Recall Repair Instructions

NHTSA Recall # 25V-481

Tiffin Motorhomes Recall # TIF-145

Purpose: To reconfigure the secondary alternator so that it only charges the house batteries when the engine is operating at or above 1200 RPM.

Figure 2

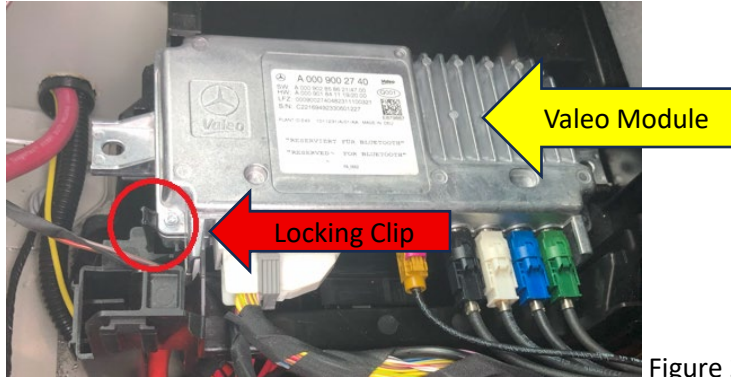
- Remove Mercedes Valeo Module shown in figure 2 by pulling up on the front edge while pressing the locking clip forward. Set the module aside to access the PSM below it.

Figure 3A

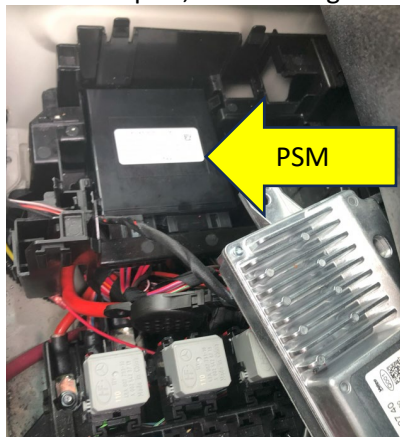
- Remove the PSM shown in Figure 3A, which is also secured with snap-in clips and remove the PSM to access the connector pins, shown in figure 3B.

Figure 3B

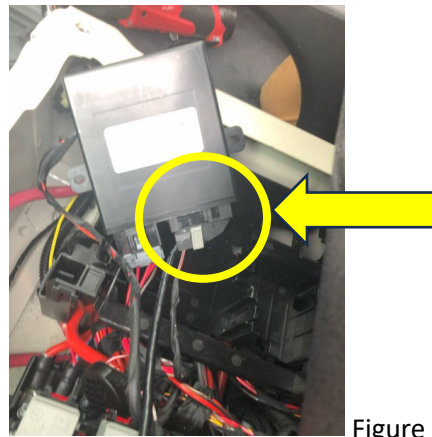
- Disconnect the wiring harness, shown in figure 3B & 4A from the PSM. Insert wires from the communication cable, part 5177529 as shown. Figure 4B, Pin 16, connect to white with brown stripe CAN wire from Wakespeed or RJ45 Pin 2. Figure 4C, Pin 32, connect to brown CAN wire from Wakespeed or RJ45 Pin 1 **NOTE: The cable provided with the parts kit will be loomed.**

Figure 5A

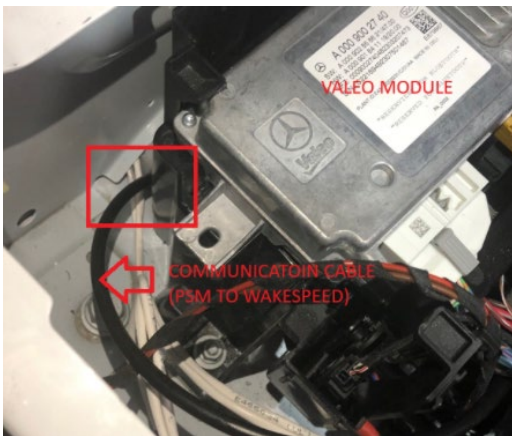
7. Route Communication cable (PSM to Wakespeed #5177529) through hole under driver's seat, see Figure 5A red square, back to the rear of the unit. Route along chassis rail, using zip ties to secure the cable as needed, see Figure 5B & 5C.

Figure 6C

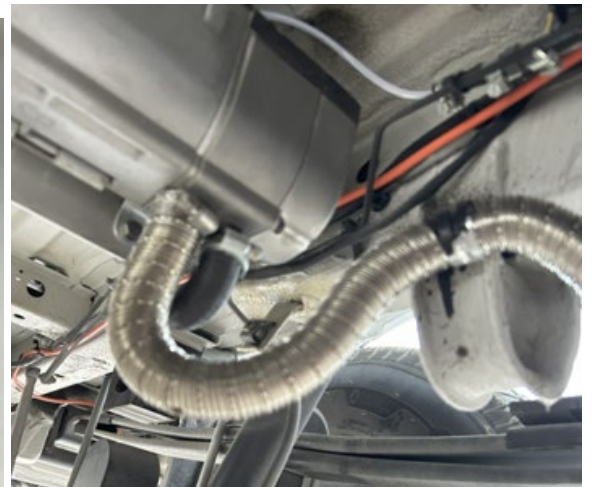
8. Once past the holding tank, turn back over frame, zip tie and continue toward the rear of the unit, see figures 6A, 6B & 6C. **NOTE: Ensure the communication cable does NOT touch any hydronic hoses or is too close to the tank sensor.**

Figure 8

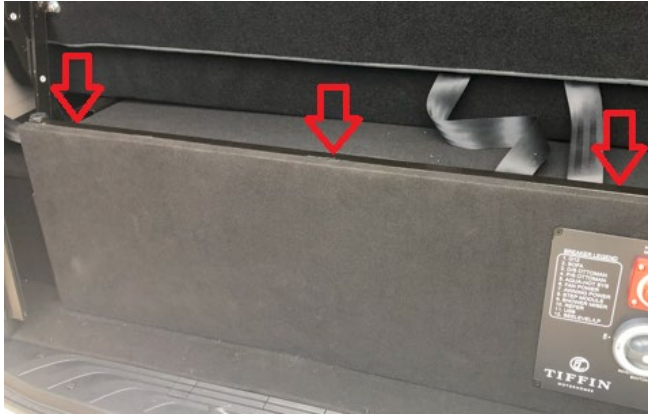
10. On units with 4 batteries the rear panel, Figure 8, will need to be removed. Screws are located along the top/rear side of the panel.

Figure 13D - Toggle OFF "Sense RPMs via Stator Wire"
Leave ON "Use RPMs to select Half Power Mode"
Ensure threshold remains at 1200 RPMs

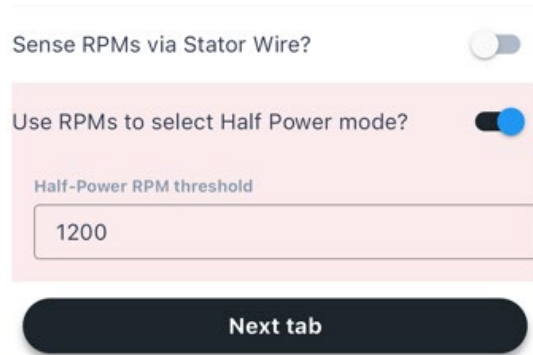
- Input the settings shown below in Figures 13A, 13B, 13C, 13D, 13E, 13F & 13G.
